**ADDENDUM NO. 3
TO
CONTRACT DOCUMENTS**

**STAGE II WASTEWATER TREATMENT PLANT
FLOOD PROTECTION PROJECT**

BID PACKAGE #B06-2022

August 31, 2022

M-14

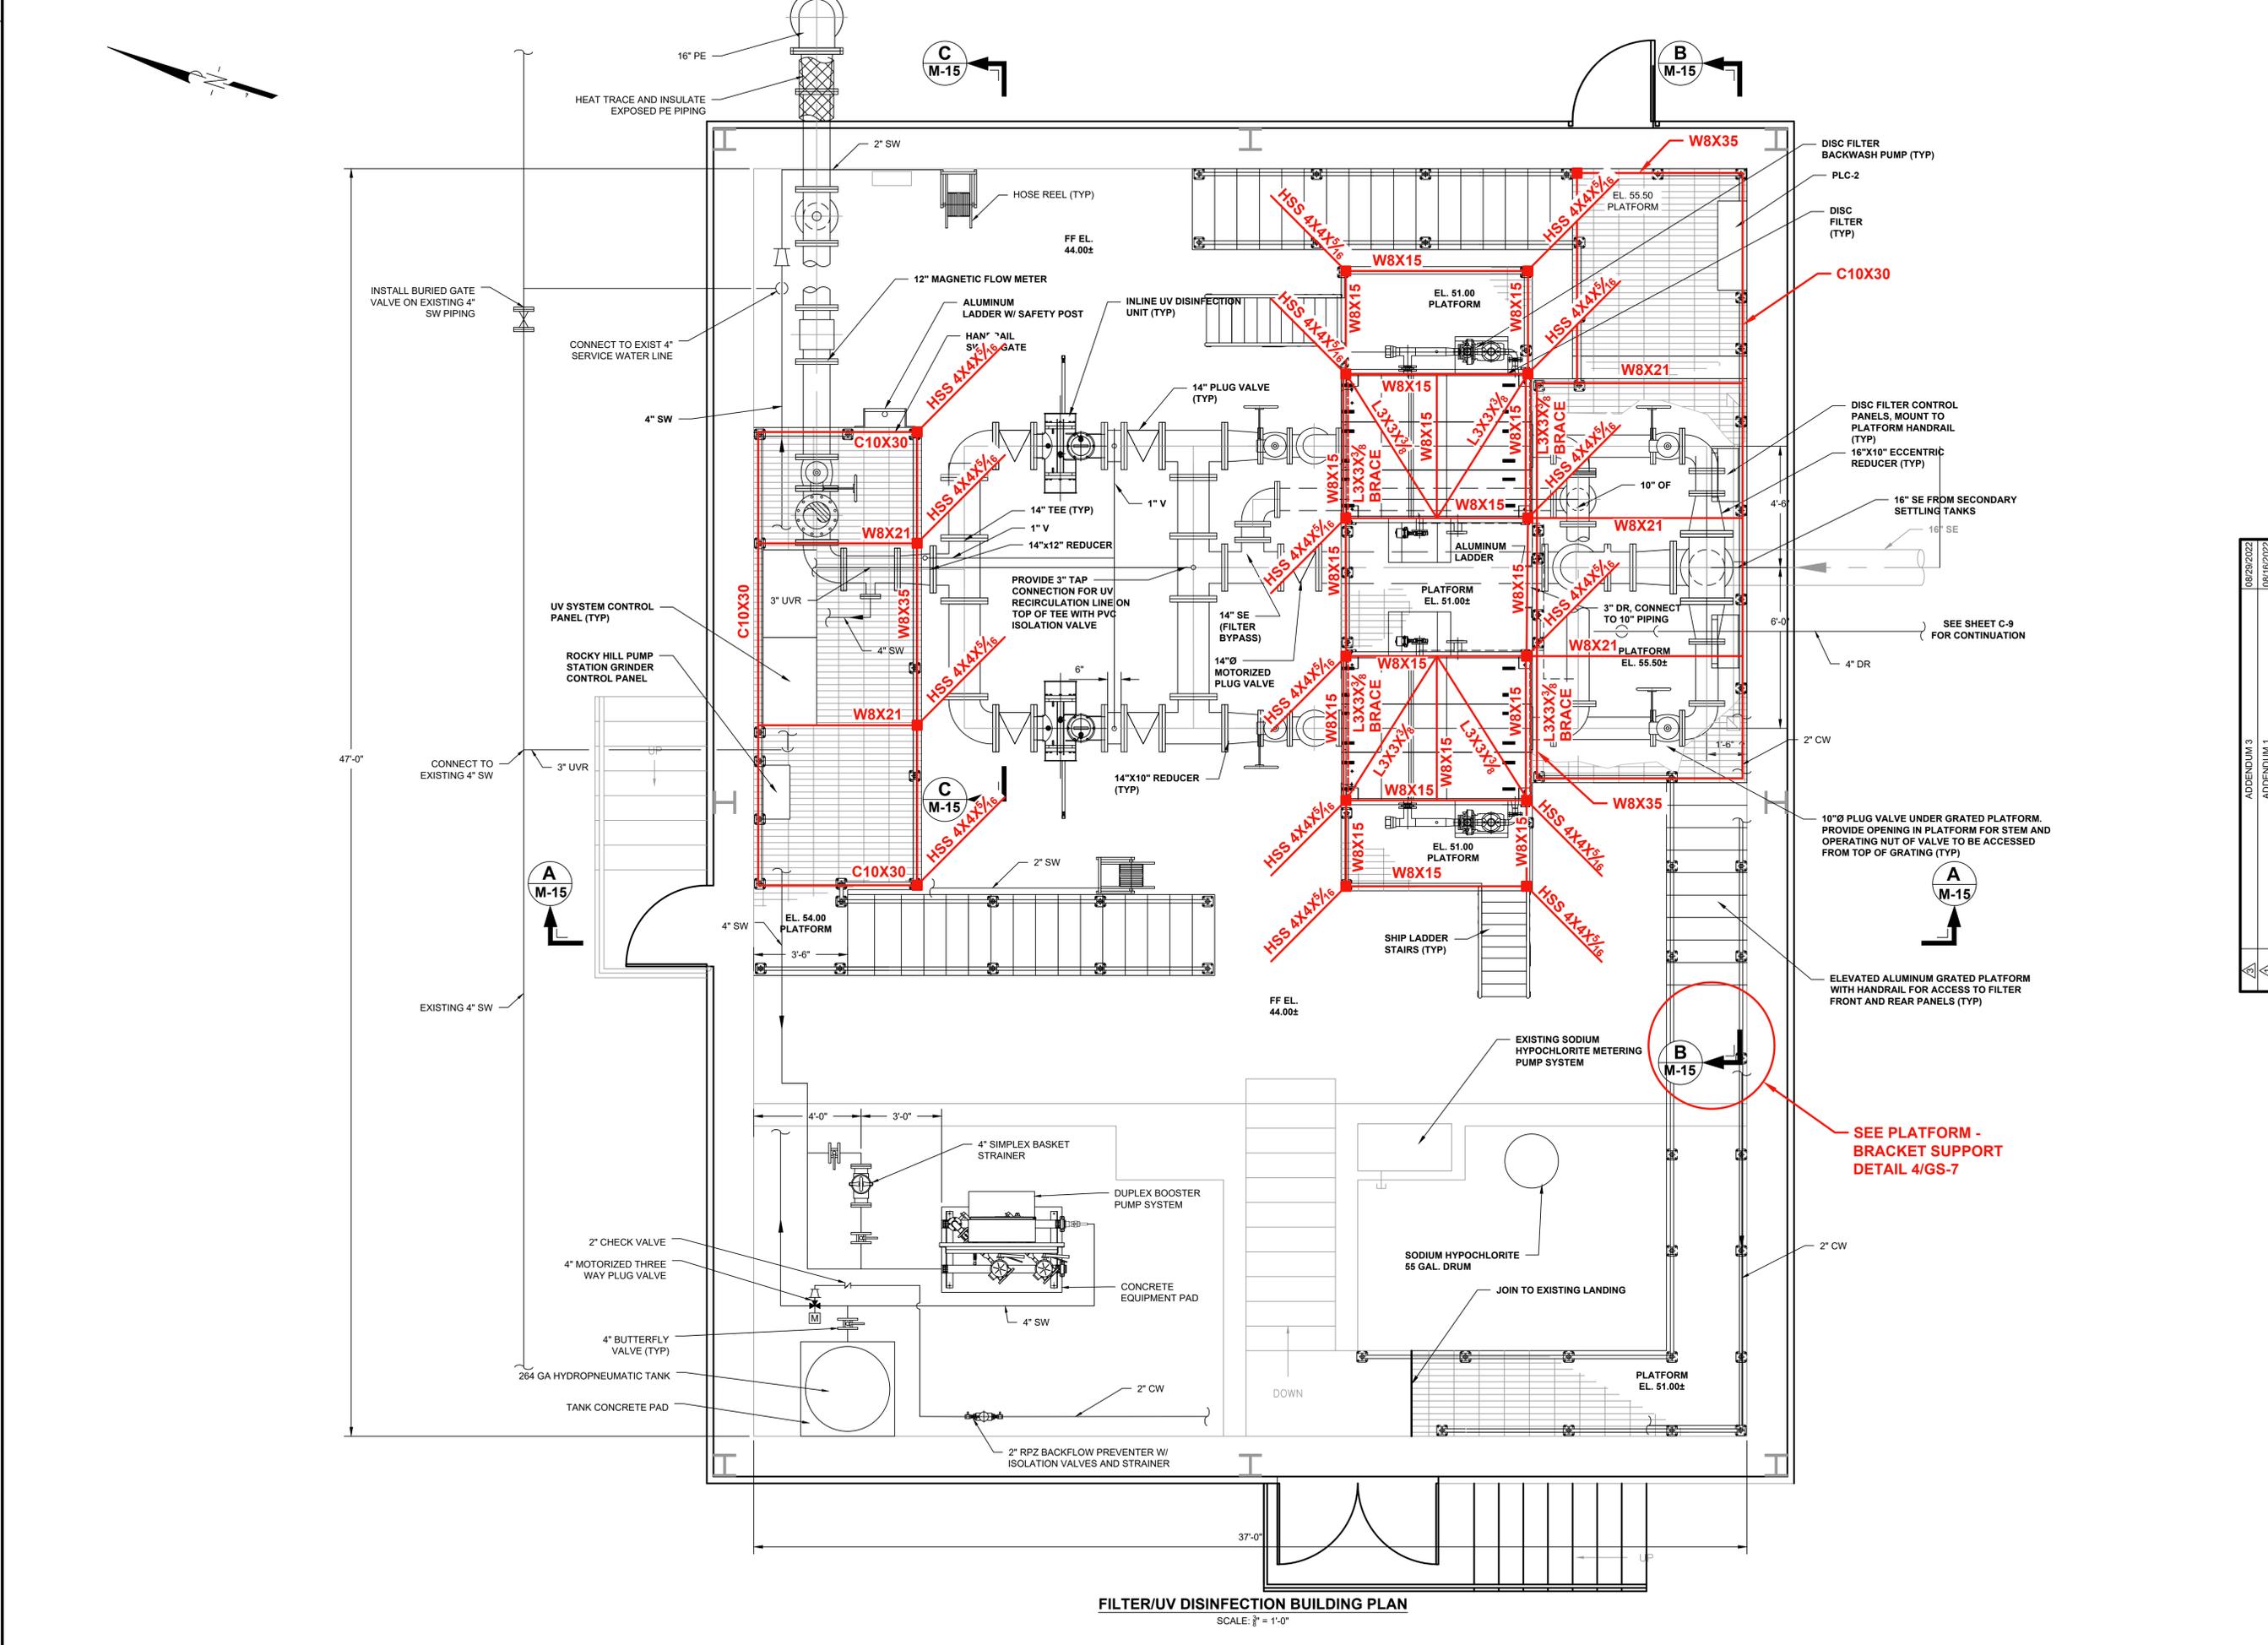
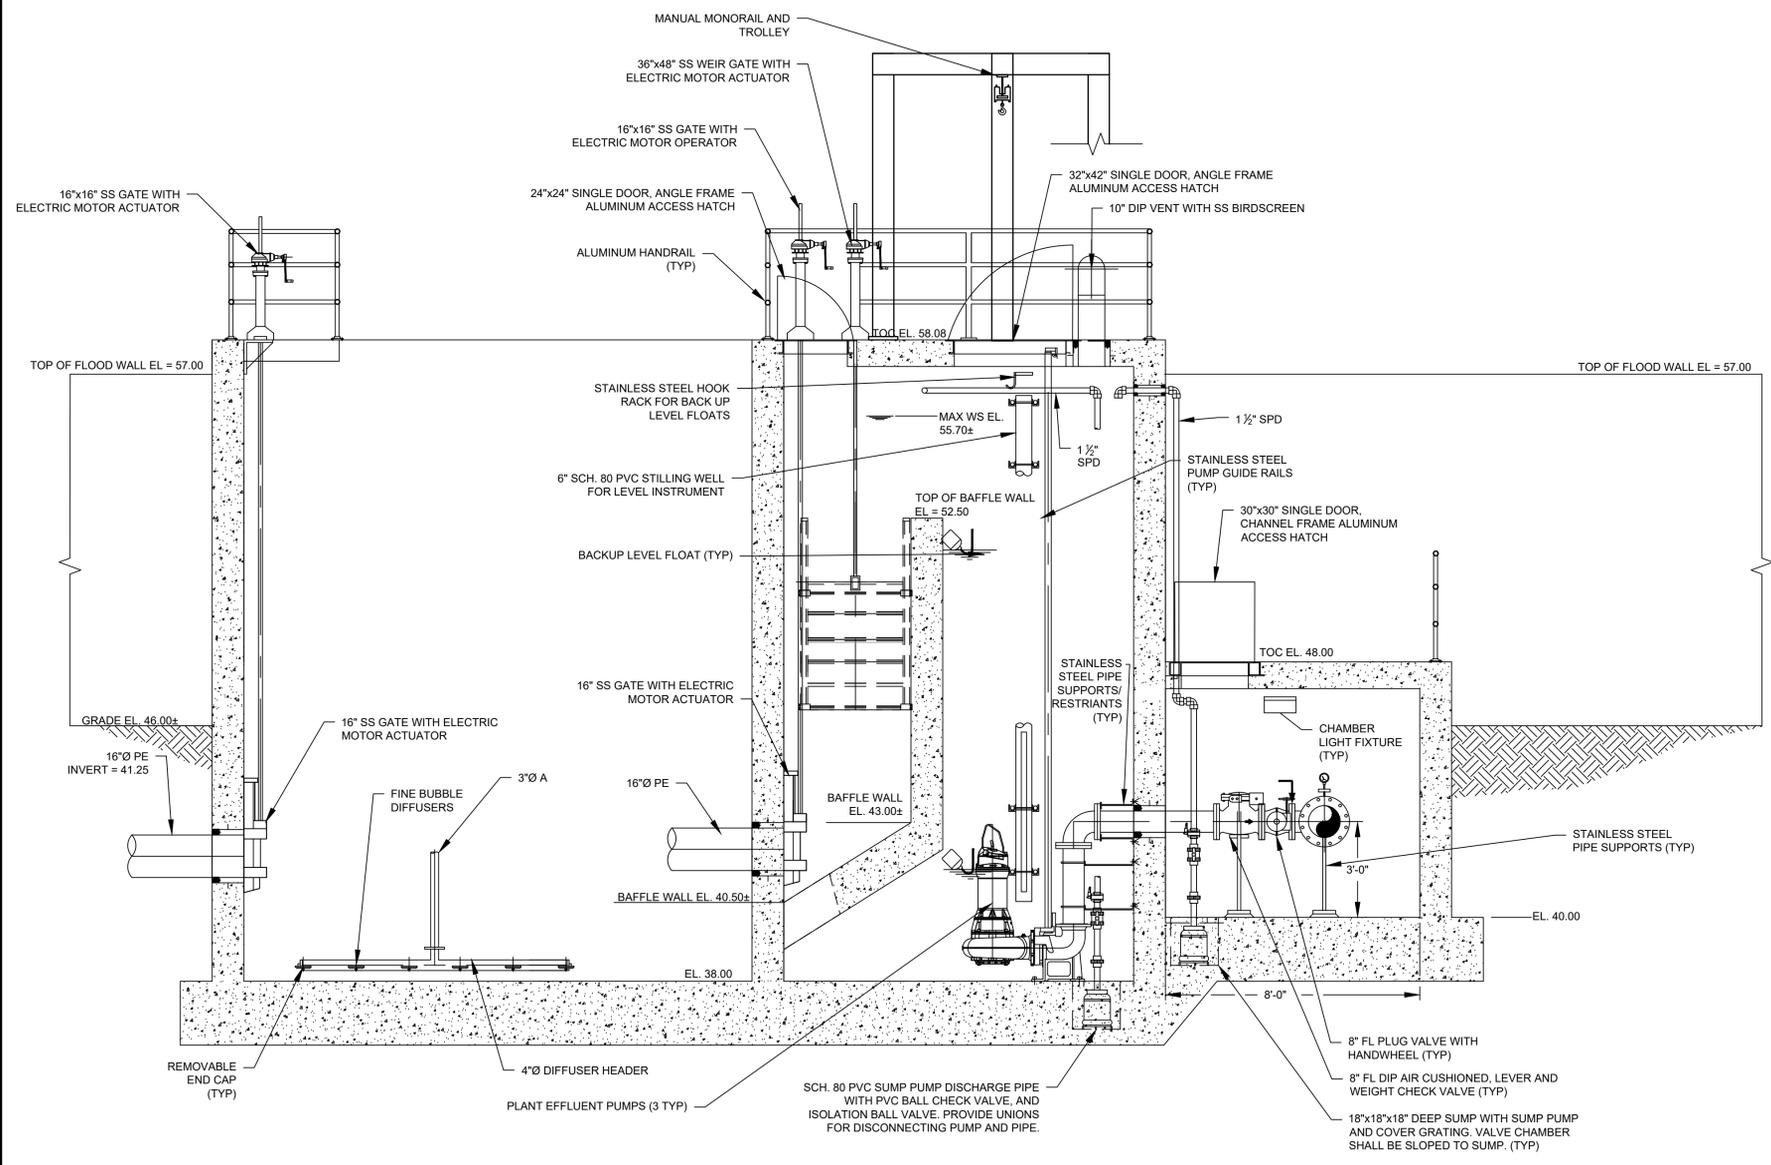
39. With regard to the elevated platforms shown on Dwg M14 for the Filter-UV Disinfection Building, please clarify the following: (a) the Platform Elevation for the platform in the upper right corner of the building is called-out as Elev. 54.00, but we believe that it should be Elev. 55.50; (b) please indicate the expected column spacing to support the dead load of the equipment as well as the personnel loads for the Equipment Platform;

Response: (a) The platform elevation for the platform in the upper right hand corner of the Building on Sheet M-14 shall be elevation 55.50+/-; (b) and (c) Refer to the attached markups on Sheets M-14, M-16, M-18 and M-22 for sizes and locations of beams and columns for the platforms that may be used for bidding purposes. Note that an analysis of beam and column sizes has not been performed by the Engineer and the Contractor shall determine final requirements as part of their delegated design.

SLUDGE STORAGE TANK PLAN AT ELEVATION 60.00
SCALE: 3/8" = 1'-0"

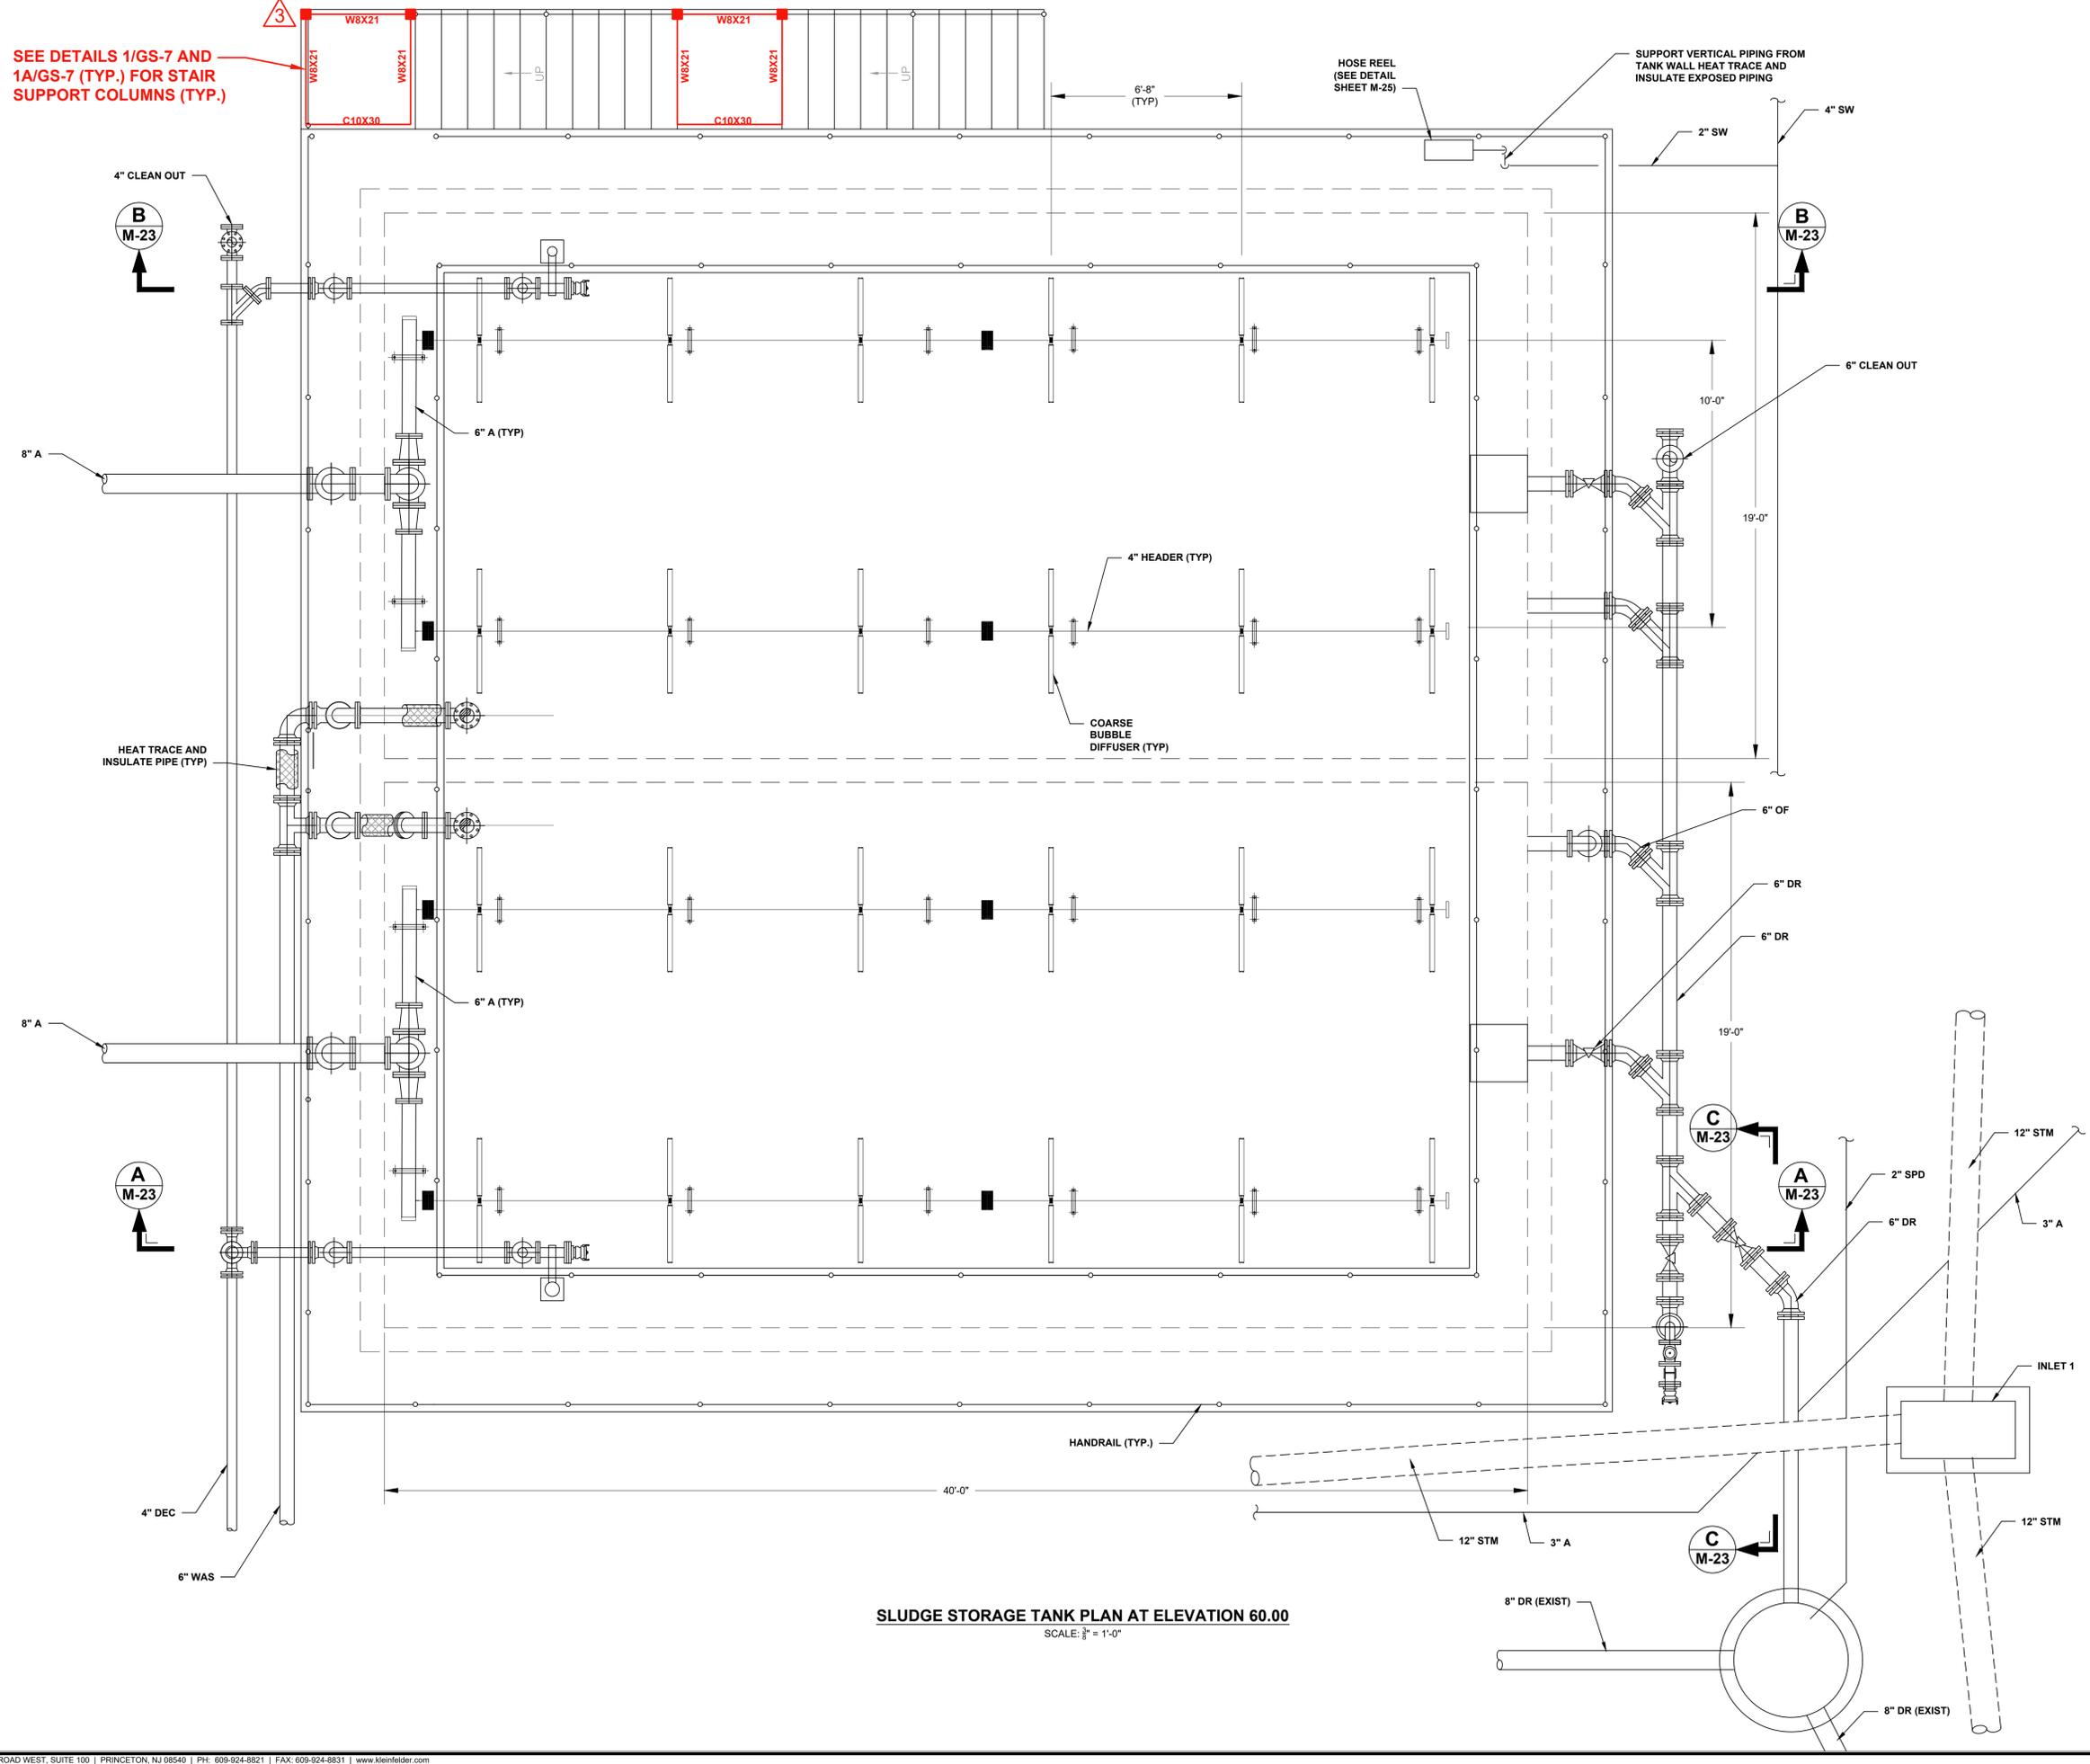
20. We believe that some of the Aluminum Gratings, Walkways and Platforms for the various structures will require intermediate supports to be provided, which is due to the geometry as well as the widths and lengths. Please revise the drawings to show the locations and sizes of the intermediate supports that will be required to support the Aluminum Gratings, Walkways and Platforms.

Response: Requirements for intermediate supports for the walkways and personnel platforms shall be developed by the Contractor as part of their delegated design. Refer to the attached markups on Sheets M-14, M-16, M-18, M-22 and GS-7 for sizes and locations of beams and columns for the platforms that may be used for bidding purposes. Note that an analysis of beam and column sizes has not been performed by the Engineer and the Contractor shall determine final requirements as part of their delegated design.

1 TYPICAL NEW PLATFORM FOOTING - SECTION
GS-7
1" = 1'-0"

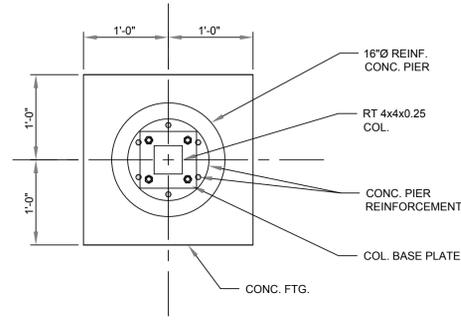
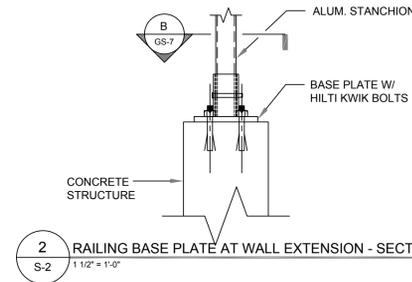
38. With regard to Dwg M16, please provide information that shows how the intermediate landing of the two flight Access Stair for the Effluent Pump Station is to be supported. It would appear that at least four columns and footings are needed to support the intermediate landing.

Response: Refer to the typical platform footing – section detail on Sheet GS-7 for the support columns for the stair landing.

5 PLATFORM - BRACKET SUPPORT - SECTION
GS-7
3/4" = 1'-0"

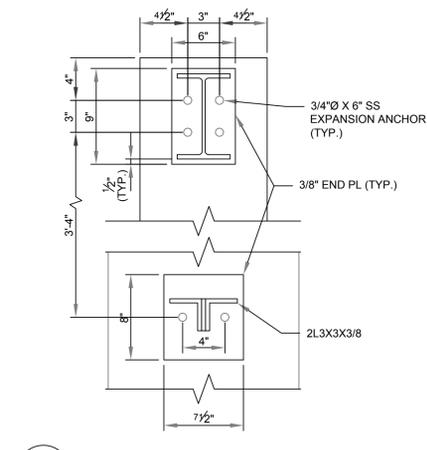
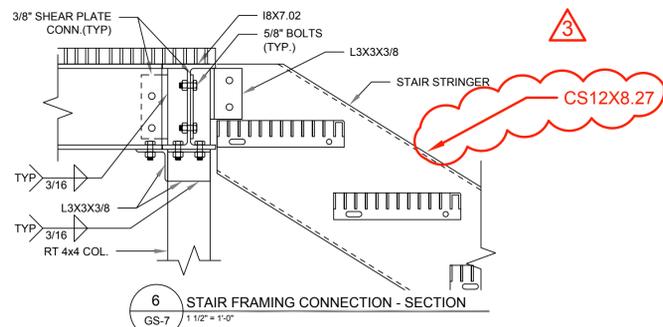
19. Dwg GS7 provides typical details for Aluminum Platforms, Walkways, Gratings and Railings, and these details call-out sizes for some of the structural members. However, not all structural members are identified by size on this drawing. It would be appreciated if this drawing could be revised to show the sizes of all structural members that will be used to fabricate and construct the Aluminum Platforms, Walkways, Gratings and Railings.

Response: Requirements for structural members for the aluminum stairs, walkways and personnel platforms shall be developed by the Contractor as part of their delegated design. For bidding purposes, the beam size for the Platform Bracket Support Detail 4/GS-7 and the stair stringer size on Detail 6/GS-7 have been added to Sheet GS-7 and is attached to this Addendum.
